Item: TB261.1

Description: Camshaft Wear

Model Affected: Tiger 1200 Alpine Edition, Tiger 1200 Desert Edition, Tiger 1200 GT, Tiger 1200 GT Pro, Tiger 1200 GT Explorer, Tiger 1200 Rally Pro, Tiger 1200 Rally Black Edition, Tiger 1200 Rally Explorer

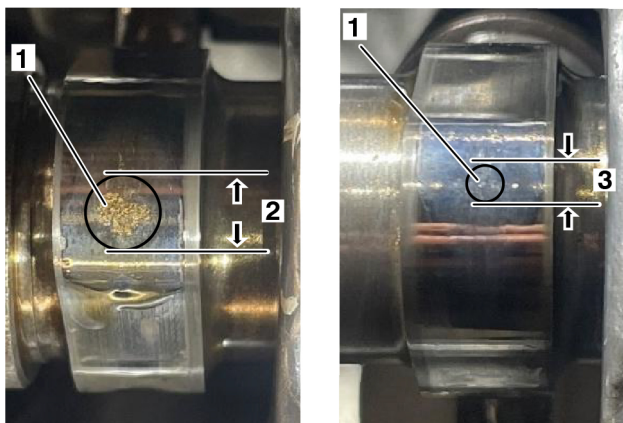
At the 20,000 and 40,000 mile service, while checking the valve clearance, dealers are requested to inspect the camshaft lobes for signs of pitting.

Dealers are to renew the camshafts if one or more of the following conditions are met:

- The pitting area on the tip of the camshaft lobe is greater than 3.5 mm in diameter.
- If there are signs of porosity (casting void) no matter the size of the pitting diameter.
- Visual pitting of any size with a noticeability reduction of engine performance.
- Visual pitting of any size with a change of engine/cylinder head noise.
